Work Order ID 108779

Item Name: Aft Crosstube - High

DART AEROSPACE LTD	Work Order: 108779
Description: Crosstube High Aft (412)	Part Number: D412-664-203
Inspection Dwg: D412-664-243 Rev: E	Page 1 of 1

DRAWING NO. D412-664-243	TITLE CROSSTUBE ASS'Y (412 HI AFT)	REV. E	DART AEROSPACE LTD ENGINEERING ORDER		D.E.O. NO. D412-664-243-E-2	SHEET NO. SHEET 1 OF 1	SCALE NTS
DRAWN 92	CHECKED AS	MFG. APPR. E	APPROVED MP	DE APPR. H			
DATE 11.09.07	DATE 11.09.19	DATE 11.09.19	DATE 11.09.19	DATE 11.09.19

D412-664-603
BENT TUBE

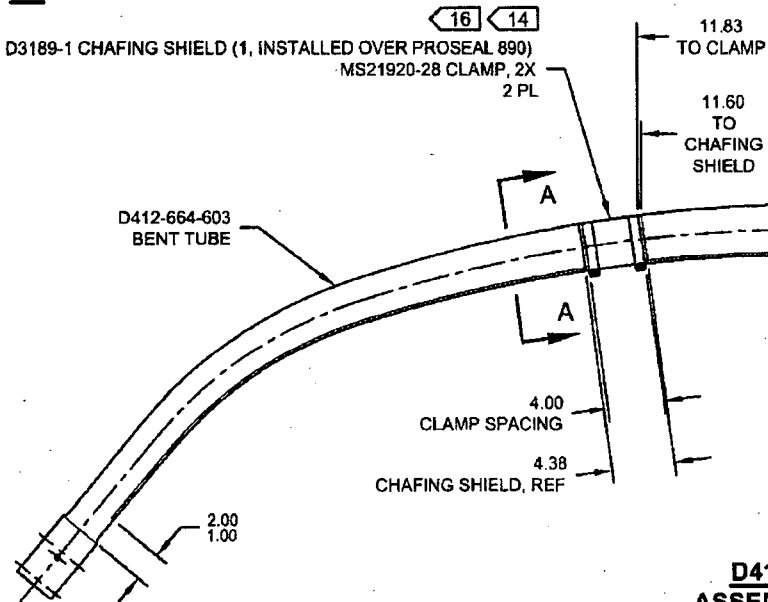
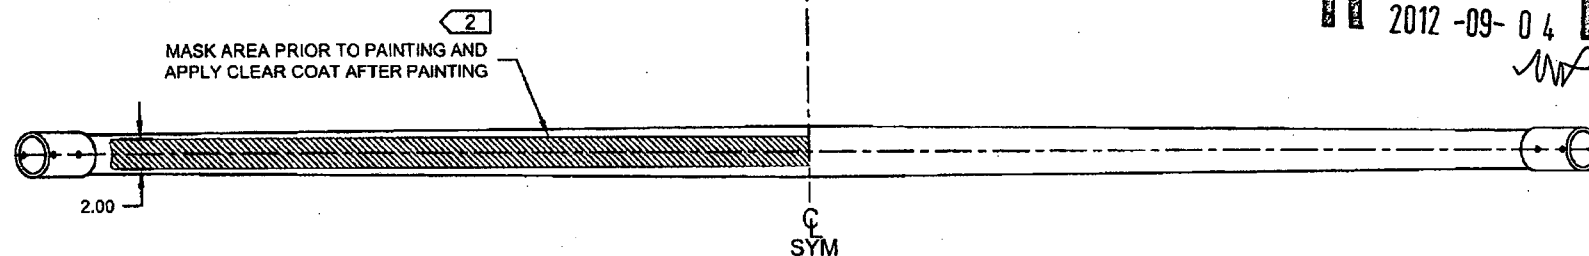
NOTES 2, 14, AND 16 ON SHEET 1 ARE AMENDED AS FOLLOWS:

IS:

D3189-1 CHAFING SHIELD (1, INSTALLED OVER PROSEAL 890)
MS21920-28 CLAMP, 2X
2 PL

WAS:

D2856-600-1009 ABRASION STRIP
D3189-1 CHAFING SHIELD (1, INSTALLED OVER ABRASION STRIP)
MS21920-28 CLAMP, 2X
2 PL

SECTION A-A
CHAFING SHIELD DETAIL
VIEW ROTATED, NOT TO SCALE

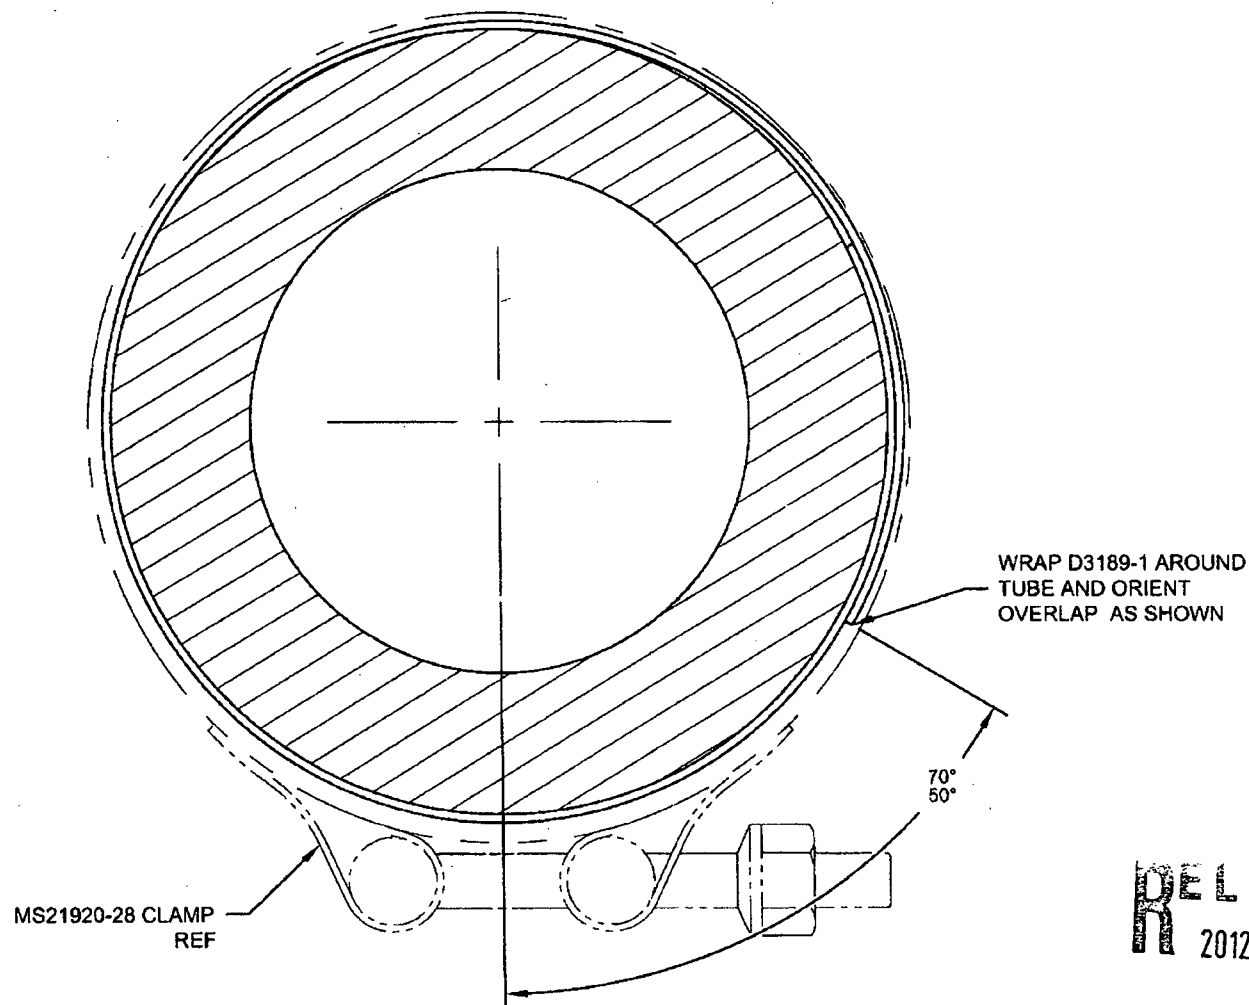
DRAWING NO. D412-664-243	TITLE CROSSTUBE ASSEMBLY (412 HI AFT)	REV. E	DART AEROSPACE LTD ENGINEERING ORDER		D.E.O. NO. D412-664-243-E-4	SHEET NO. SHEET 3 OF 3	SCALE NTS
DRAWN 92	CHECKED	MFG. APPR.	APPROVED	DE APPR.			
DATE 12.08.21	DATE 12.08.22	DATE 12.08.29	DATE 12.08.29	DATE 12.08.29
